**Proposal for a Supplement to the 01 series of amendments to  
Regulation No. 112 (Headlamps emitting an asymmetrical  
passing-beam)**

The text reproduced below was prepared by the expert from Poland to replace a requirement 1000 lm for LED light source in headlamp which was vicariously introduced the Regulation to prevent very minimalistic performance of LED headlamps worse than base on H4 halogen. The modifications to the existing text of the Regulation are marked in bold for new or strikethrough for deleted characters.

*Fig 1. Vertical illumination at the road surface to be recalculated for luminous intensities for single headlamp. Side: + Left , -Right*

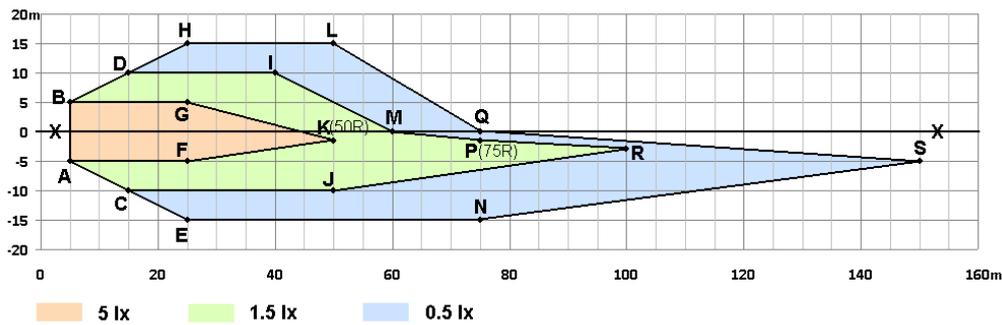
**6.2.4.1. The passing-beam equipped with LED light source(s) may alternatively meet the luminous intensities described as follows:**

For right hand traffic luminous intensities at all points in the area described on the graph (Fig.1.) and in Tables 1. and 2. below should be equivalent to vertical illumination at the relevant distance at the road surface defined for direction parallel to headlamp optical axis. For left hand traffic all points and values should be mirrored with respect to X-X line.

For recalculation of the vertical illumination at the road surface to luminous intensities in angular system the position of optical centre of headlamp should be taken as 0.75 m above point 0,0 (Fig. 1.) of the road surface.

Cut-off shall be aimed one per cent (0.57 degrees) below the H-H line according p. 6.2.2. Measurements shall be done by standard photogoniometric equipment in spherical coordinate measuring system as described in Annex 3. Luminous intensities reflecting illumination of all the points in the Table 1 shall be measured.

Fig. 1 Presently required illuminated area according Reg. 112 (GRE 72-24) for reference. Distances at “B” are comparable to plots above.

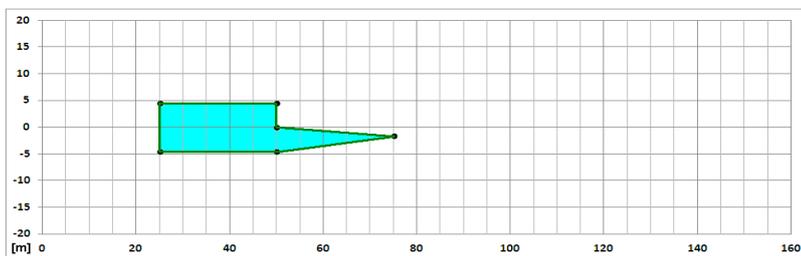
At the Fig. 1. is shown area at the road surface where requirements are defined according Reg. 112 (see GRE 72-24).

It is easy to see that area and values required by Reg. No 112 are much lower and at smaller area than contemporary halogen headlamps possibilities. Because of safety reasons there is reasonable to require at least **similar to halogen level of road illumination by LED headlamps**. Especially because in common understanding LED technology is better than HID. For today it is unfortunately not general truth.

Fig. 2. Proposed areas and vertical illumination at road surface.(For two headlamps on the vehicle values **will be doubled**).

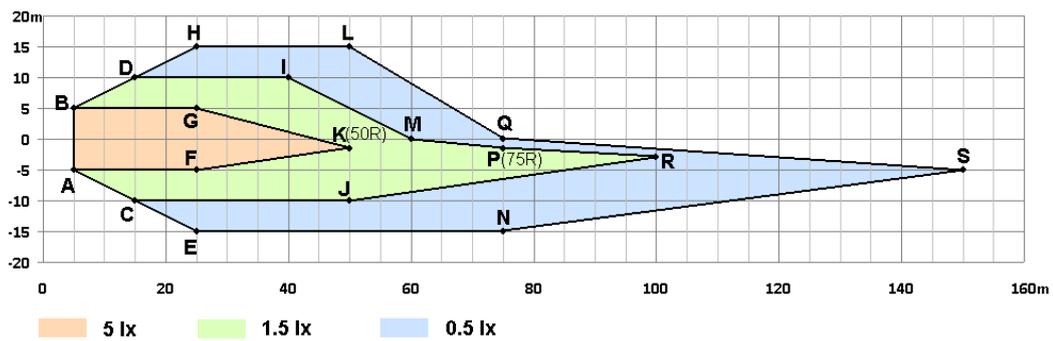
Based on above examples of real headlamps and take into account CIE standard expectations regarding range and width it is proposed to define requirements according Fig. 2. below.

It represent reasonable good (not the highest) level of contemporary halogen headlamp performance. When comparing above real examples and the lux values of proposal (Fig. 2.) **proposed values shall be multiplied by two** because requirements are described for single headlamp when in the vehicle pair of headlamp is installed.

The proposed lux values follows CIE standard: 1lx and 3lx for “range” and “width” and 10 lx for central and foreground area.

Fig. 3. Present requirements on the background of proposed.

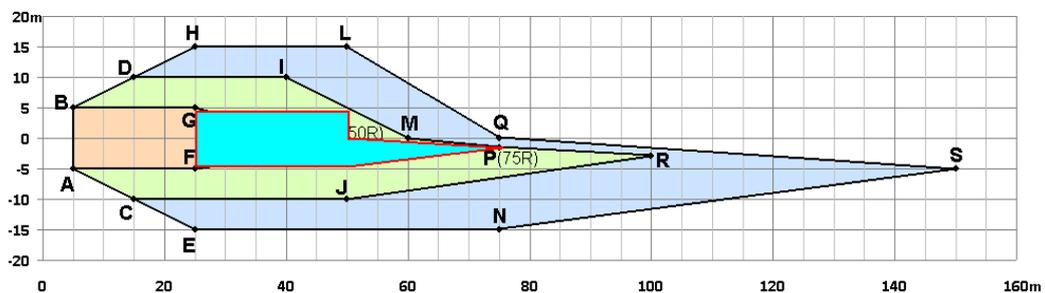
On Fig. 3 is shown present required area on the background of the proposed. It easy to see the difference between contemporary “halogen level” and suggested by other proposals “minimum LED level”. If will be **removed 1000lm LED requirement** from Reg.112 without any additional road illumination requirements the **range will be decreased 2 times and width 3 times** comparing present average road situation.
